REQUEST

Current Zoning: R-3 (single family residential) and R-I (religious institution)
Proposed Zoning: INST(CD) (institutional conditional) and INST (institutional)

SUMMARY OF PETITION

PLANNING STAFF REVIEW

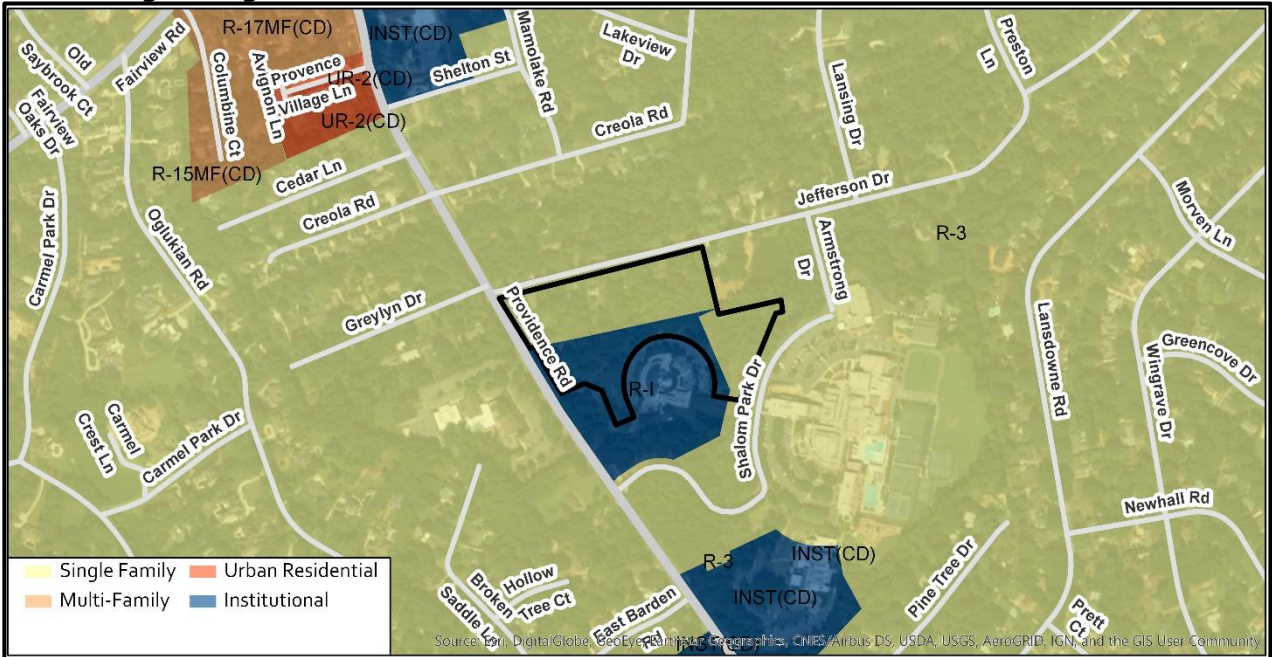
1. ~~Provide building stepbacks, reducing the building height for the portion of buildings 2 and 3 along Jefferson Drive.~~ Addressed
2. ~~Provide additional cross-sectional views for building 4 (B2—east/west closer to Jefferson Drive) and (B3—north/south from single family across Jefferson Drive).~~ Addressed
3. ~~Amend note 5a to specify that "the width of the buffer shall not be reduced with a fence or wall."~~ Addressed

4. ~~Delete the label for "30' PCO buffer" along the stream and amend the label from the 50' SWIM buffer to read "50' SWIM/ PSCO buffer."~~ Addressed
5. ~~Show and label "Potential 30' PCSO buffer" running northwest to southeast near building 5. See City GIS data below.~~ Addressed

6. ~~Remove Note 6b (Stormwater detention) in its entirety.~~ Addressed
7. ~~Clearly show tree save areas and calculations on site map. Site is in a wedge and commercial areas will be required to provide 15% tree save area based on gross acreage. 15% of 11.02 acres = 1.65 acres tree save area. Single family detached areas must provide 10% minimum tree save area.~~ Addressed

8. ~~Amend note 4b to change the word "apartments" to "independent living units".~~ Addressed
9. ~~Amend notes 5b, c, d, and f to specify that the items will be completed prior to issuance of the certificate of occupancy for the first new building on the site.~~ Addressed
10. ~~Remove the labels "50' building height sideyard" from sheet RZ-2 as the conditional notes are more restrictive and specific.~~ Addressed
